RE: Representations relating to the Draft Tsing Yi Outline Zoning Plan (OZP) No. S/TY/31

Regarding the captioned, The Conservancy Association (CA) OBJECTS to the proposed amendments Item A.

Figure 2 From the site formation section attached in the Interim Report⁹, the proposed diverted stream has vertical stream banks on both side (marked in red)

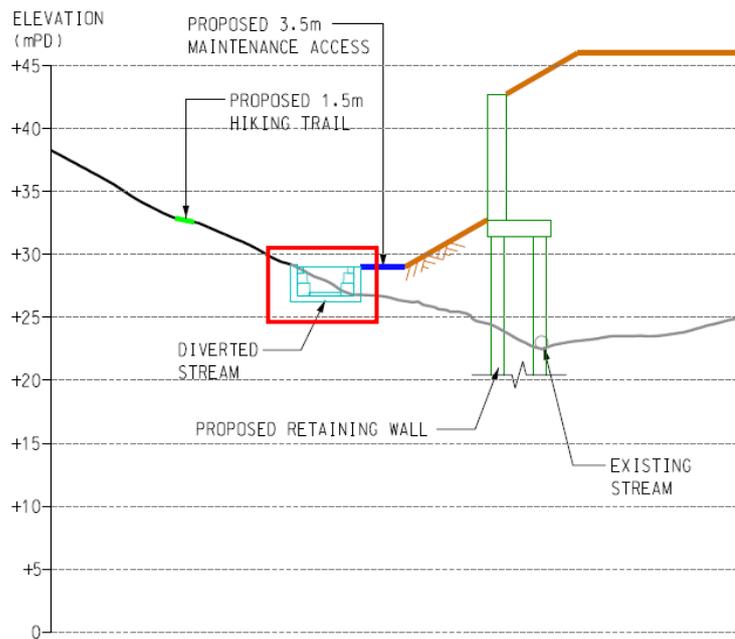
Stream diversion within the site is necessary according to the proposed development, but we are very doubtful how the current proposal would help minimize or mitigate potential ecological impact. From the site formation section attached in the Interim Report⁵, it happens as if the proposed diverted stream, with vertical stream banks on both sides, is merely an engineered, channelized watercourse (Figure 2). The report mentioned that “*Gabion walls are recommended instead of concrete banks to allow the diverted stream to naturalize over time and to create and increase availability of micro-habitats for wildlife*”⁶. However, what we worry is that vertical gabion wall leaves no space for soil and water so that not many plants would be able to grow. We also worry that the stream bed would also be formed by gabion and then the stream section would be dried out eventually. Quite often the channelized watercourse would turn out to be an ecologically-dead zone grown with invasive species.

We have to reiterate that two endemic freshwater crabs *Cryptopotamon anacoluthon* and *Nanhaipotamon hongkongense* were recorded in the stream. Stream diversion work would pose direct impacts on these endemic species. Based on the details in the Interim Report, we do not think that it is justified to say that the existing aquatic ecology can be compensated, not to say enhanced.
